DRAINAGE INFORMATION SHEET

RE: DRAINAGE PLAN FOR A TRUCK WASH TERMINAL @ UNITED PARCEL SERVICE (G16-D20) ENGINEER'S STAMP DATED 6/21/94.

RE: ENGINEER'S CERTIFICATION FOR UPS GRADING, DRAINAGE & PAVING IMPROVEMENTS DATED MARCH 26, 1991 (G-16/D20)

GRADING PLAN SITE PLAN

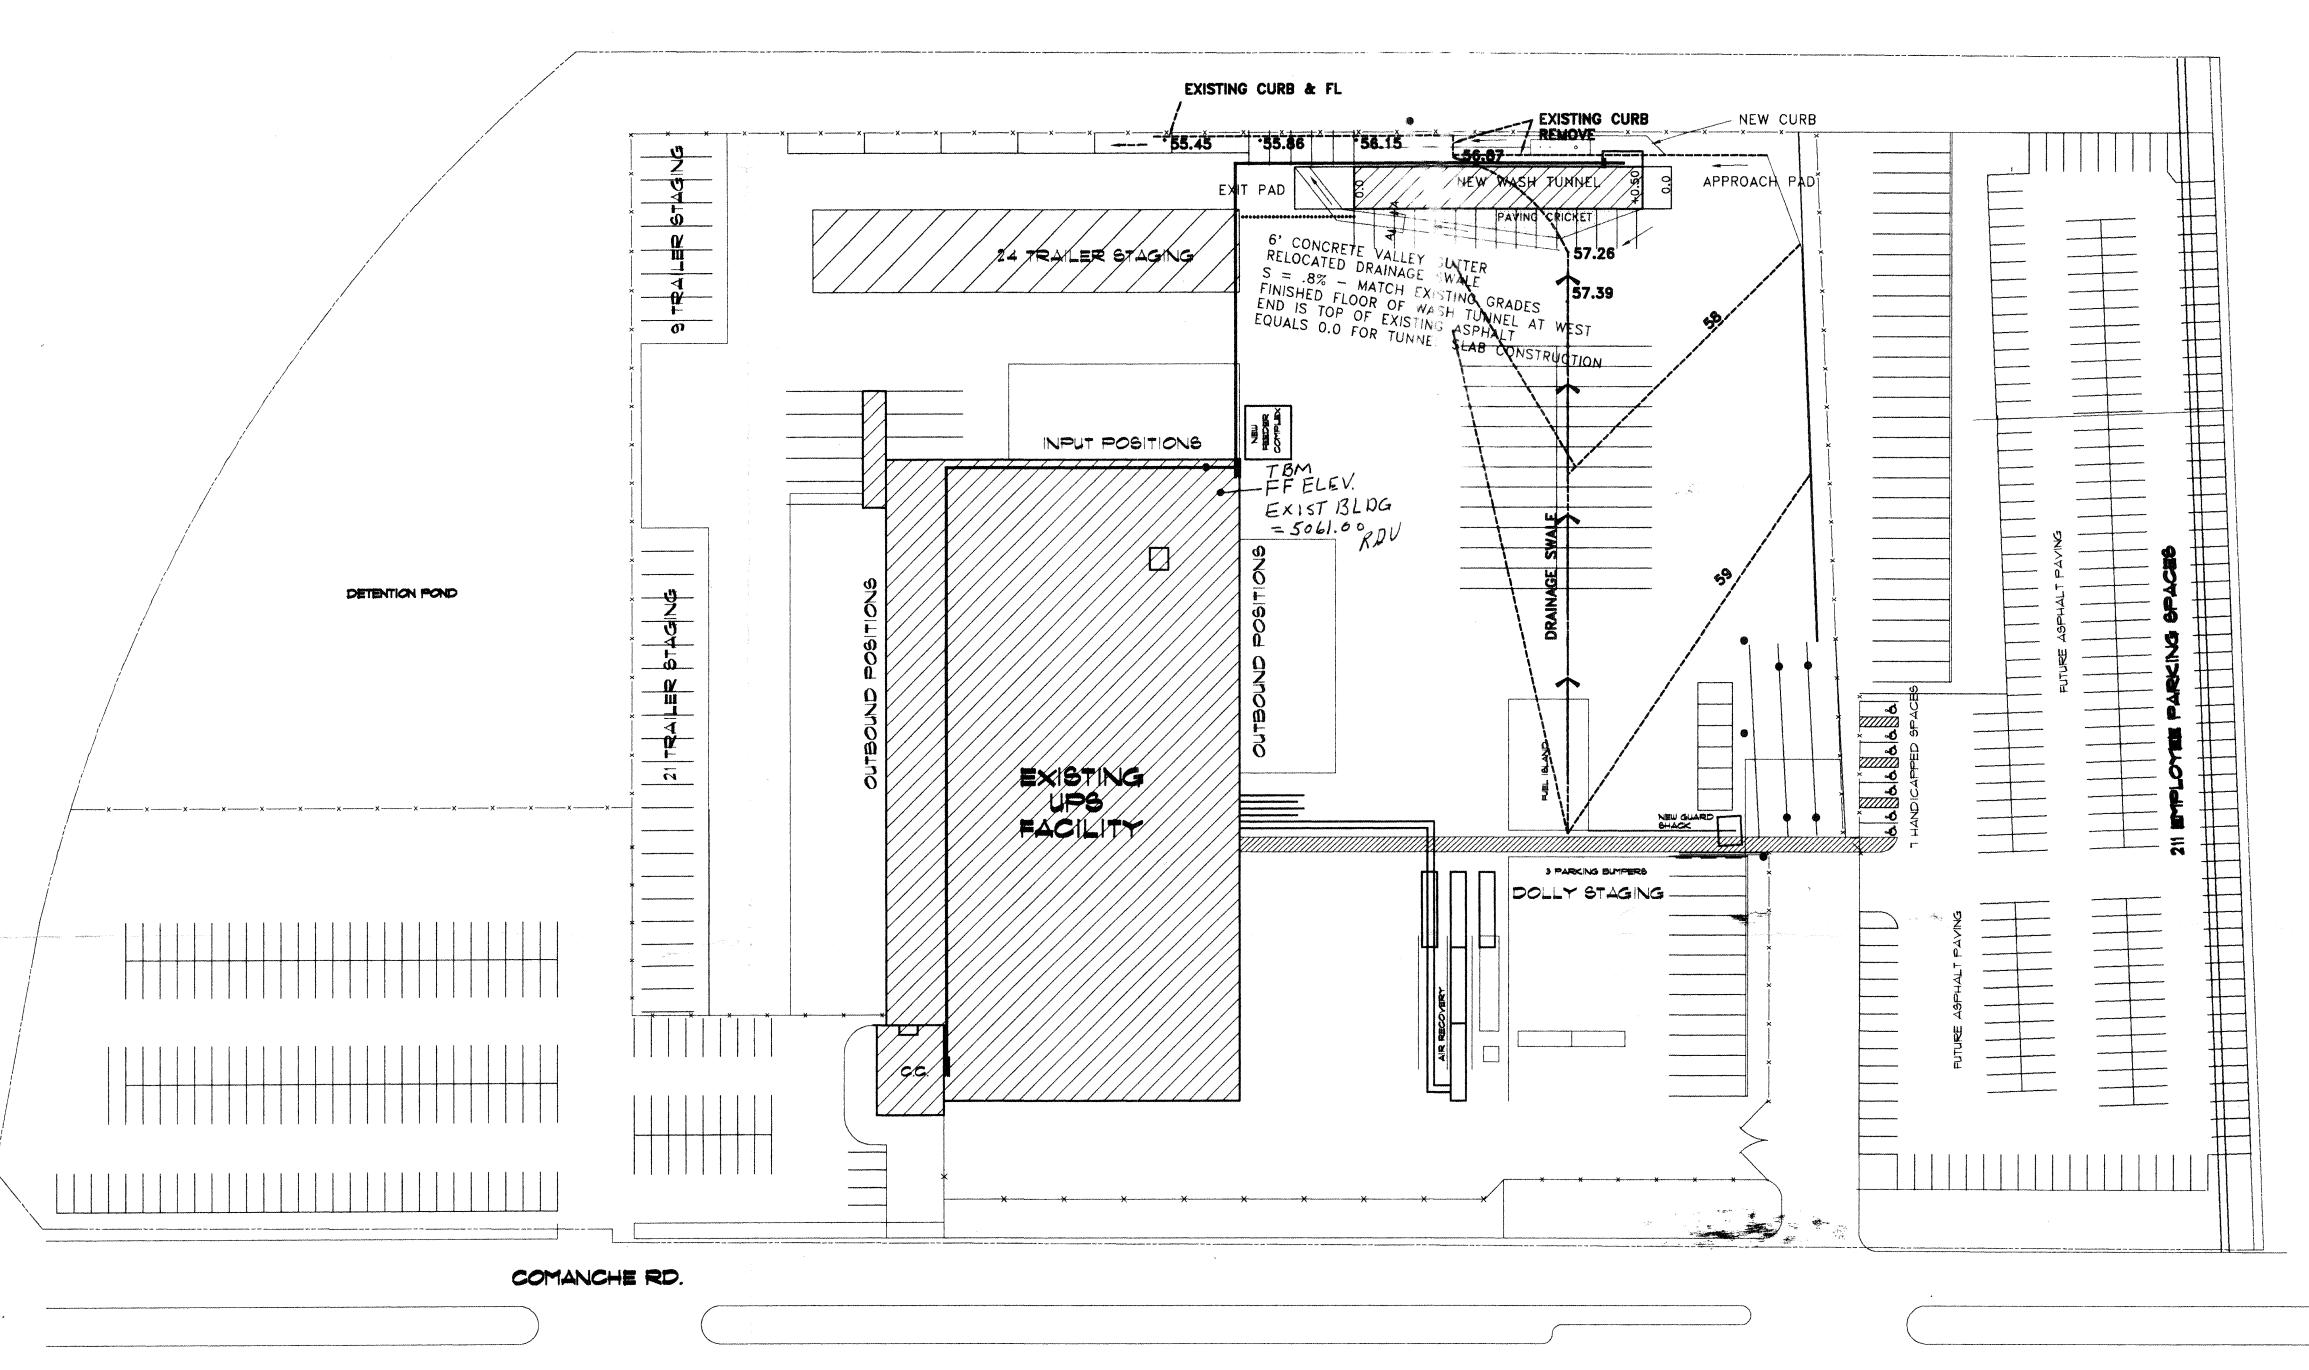
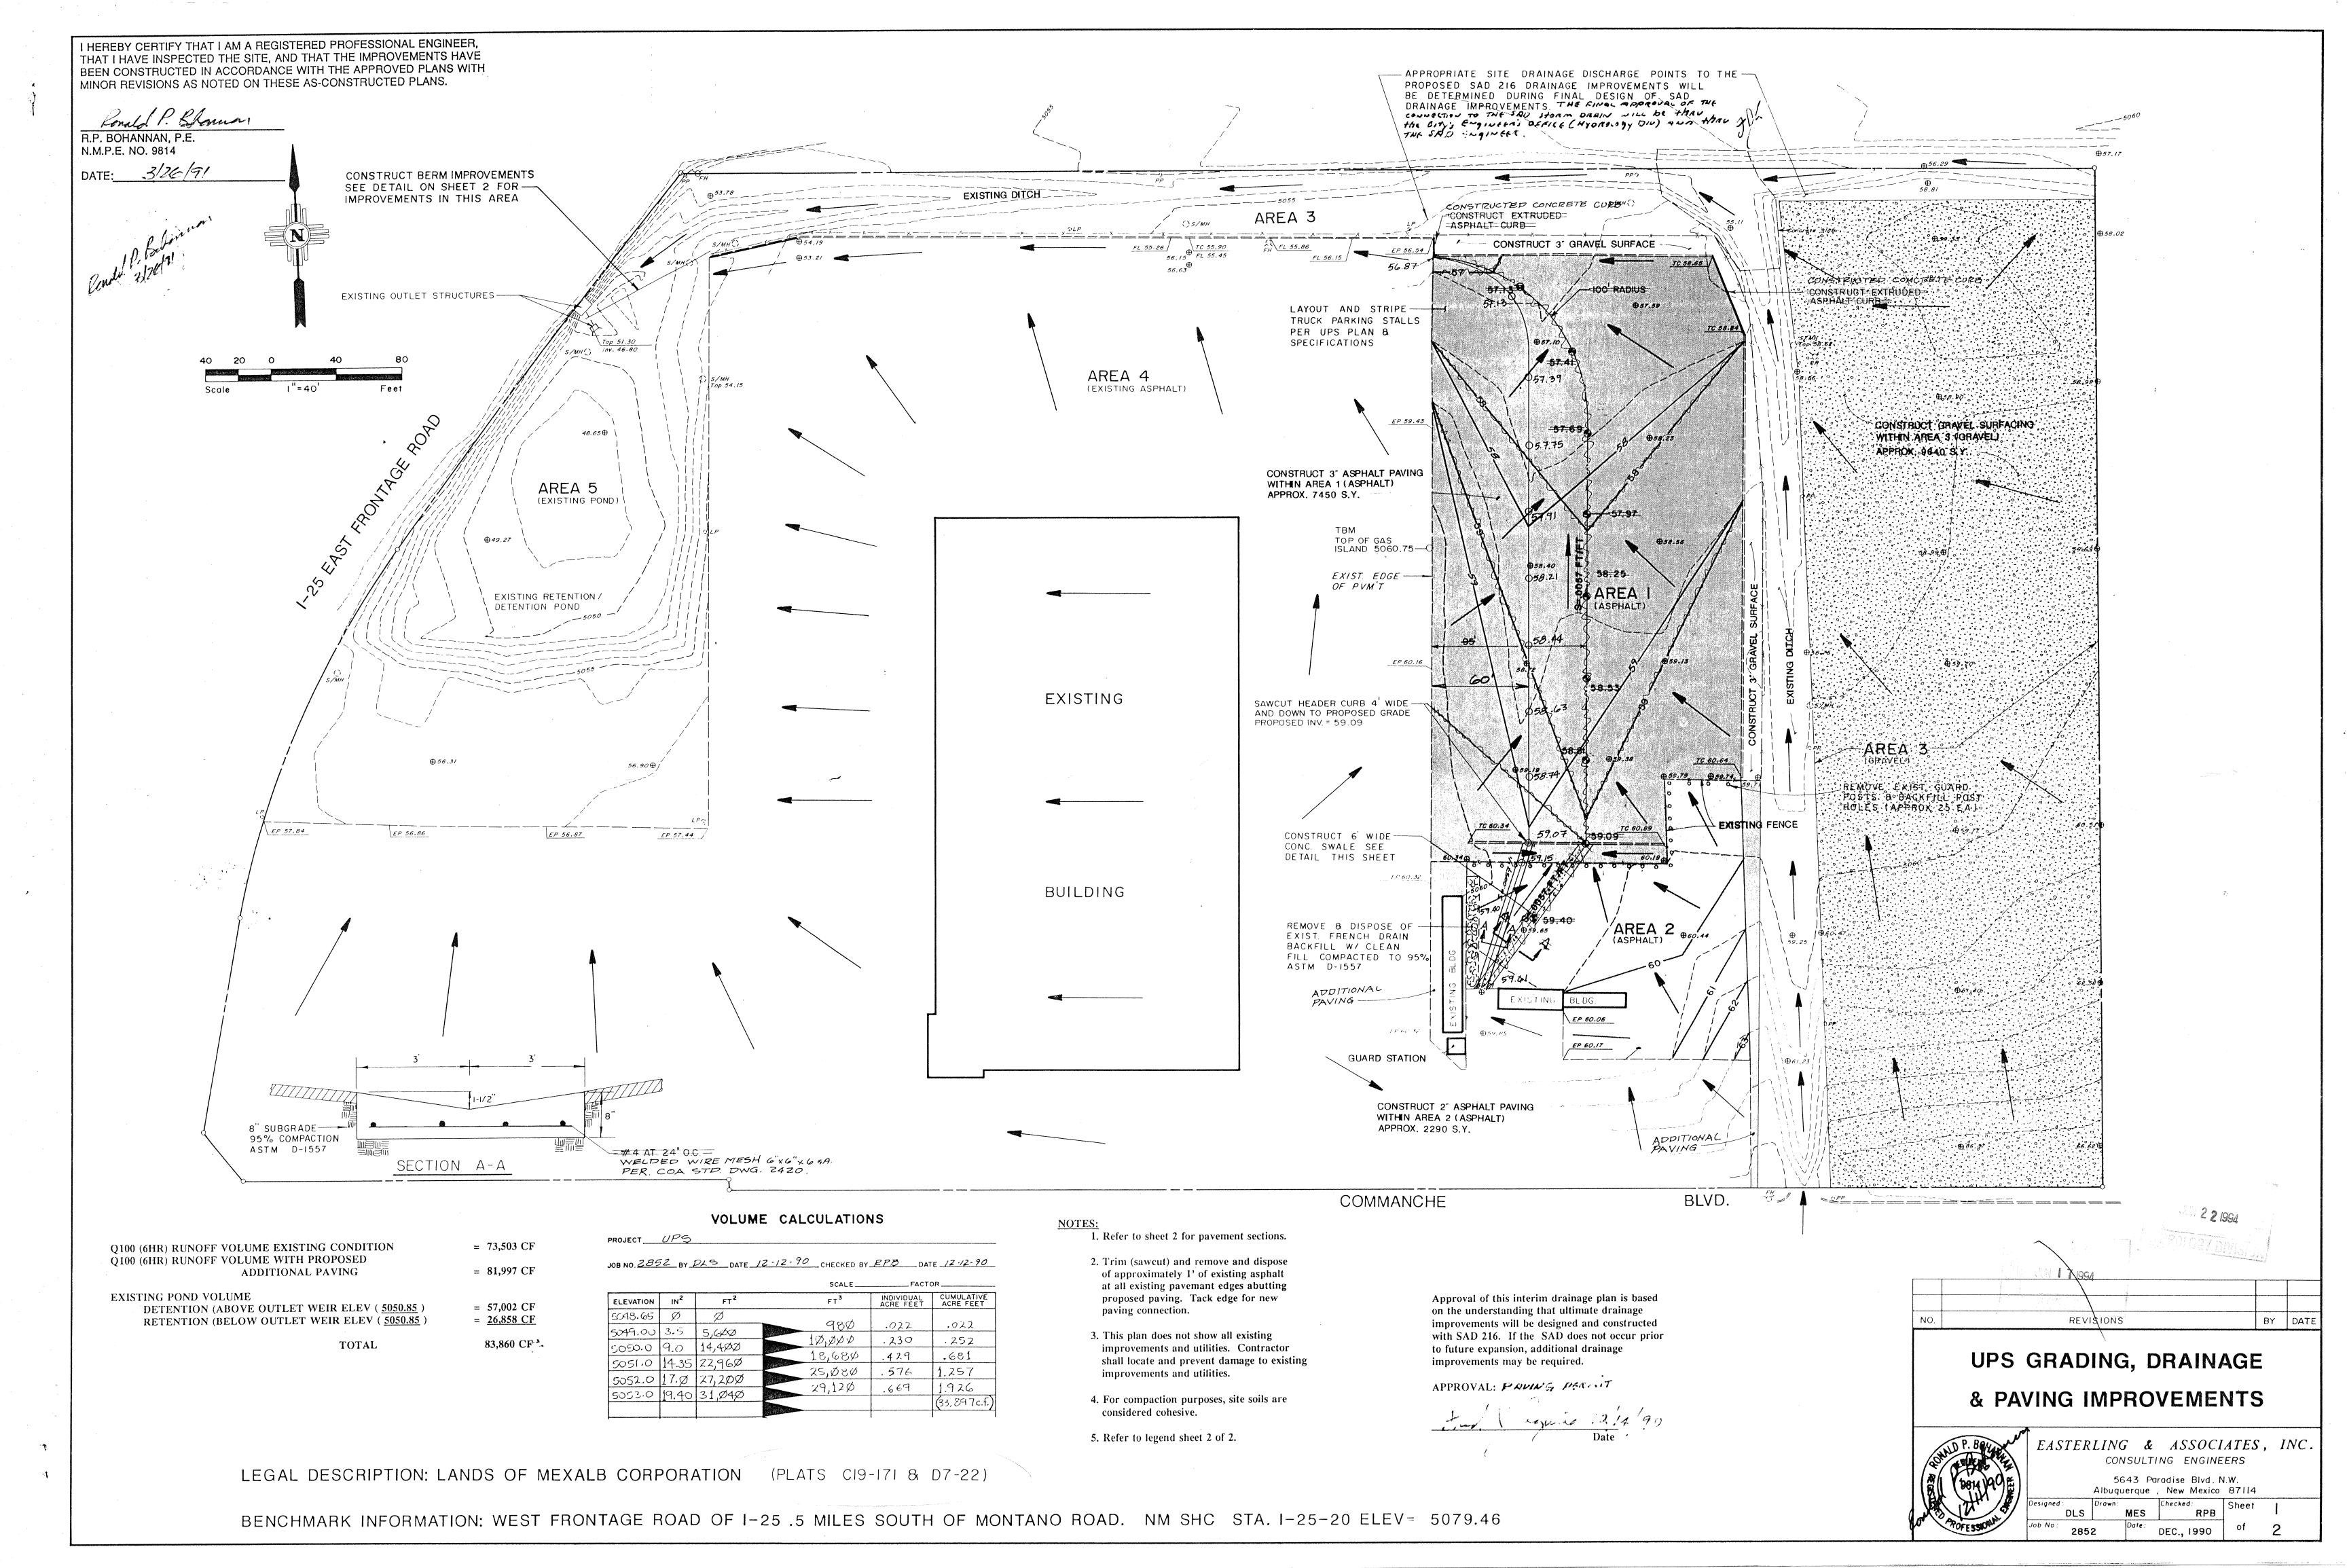
Based on the information provided on your June 22, 1994 submittal, the above referenced site is approved for Building Permit.

Please attach a copy of this approved plan to the construction sets prior to sign-off by Hydrology.

Please be advised that any further development within the U.P.S. parcel will require an updated Master Drainage Plan.

UPS GRADING, DRAINAGE & PAVING IMPROVEMENTS

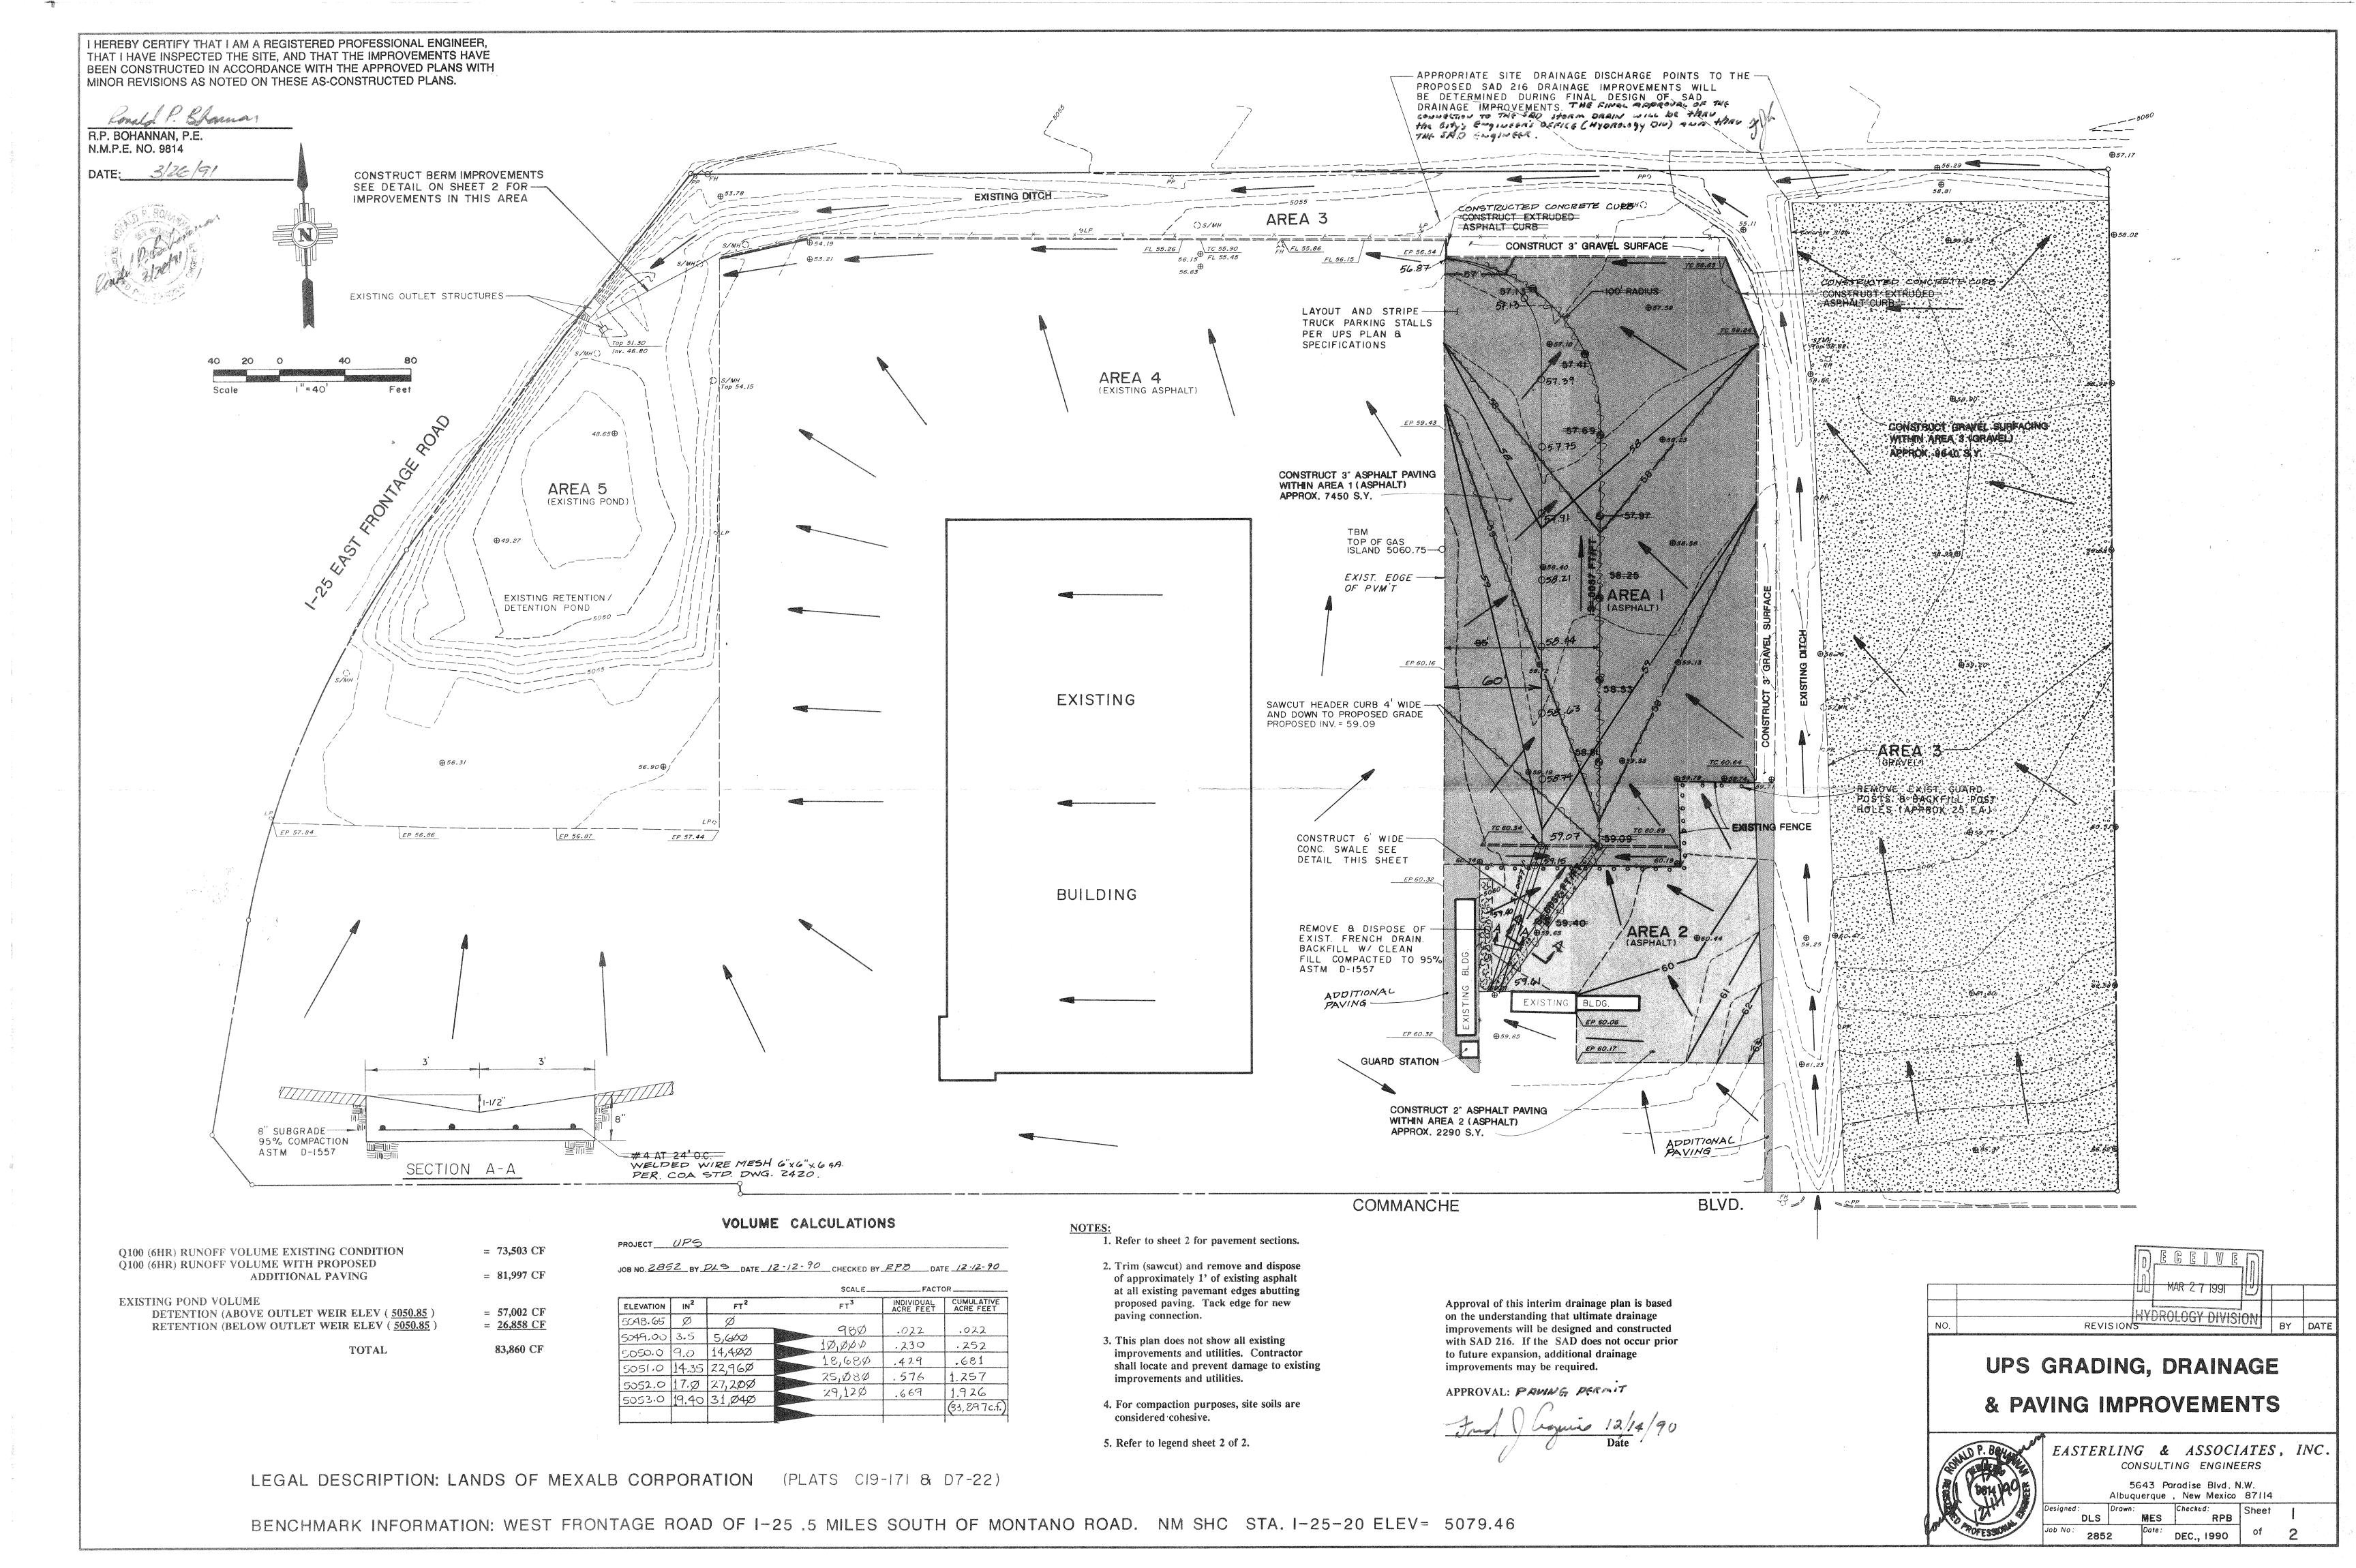
The as-built drainage plan received on March 27, 1991 is in accordance with our pre-design, hence, your submittal is approved.

The appropriate site drainage discharge points to the proposed SAD 216 drainage improvements will be determined during final design of SAD drainage improvements. The final approval of the connection to the SAD storm drain will be through the City Engineer's office (Hydrology Division) and through the SAD Engineer.
